Access Compliance Report

Public Rights-of-Way

Intersection ID: 14189	Main Street: E_KINGSTON_AV	Cross Street: EUCLID_AV	Location:	N
ADA ID: B469BCCAAC52	Ramp Type: Directional1	Initial Pass/Fail: Pass	Overall Compliance: No	Severity Score: 30

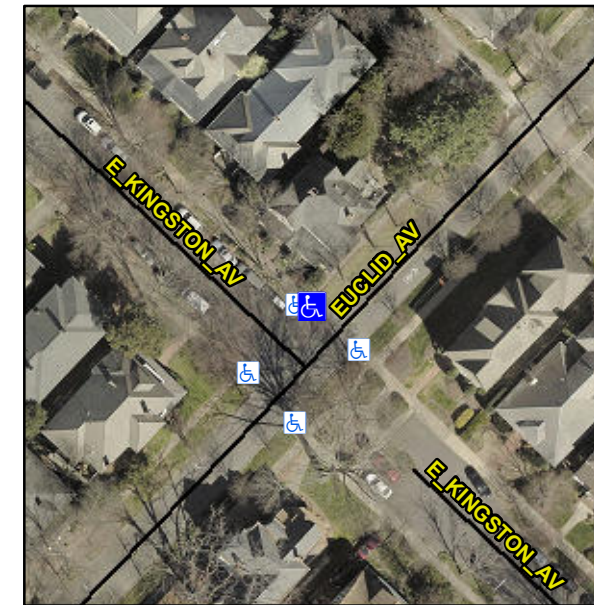
**Remove & Replace Entire Ramp.
Remove & Replace Gutter.**

**R304.2.2-Perp, R304.3.2-Para,
R304.5.3, R305, R302.7, R302.7.2,
R304.5.4**
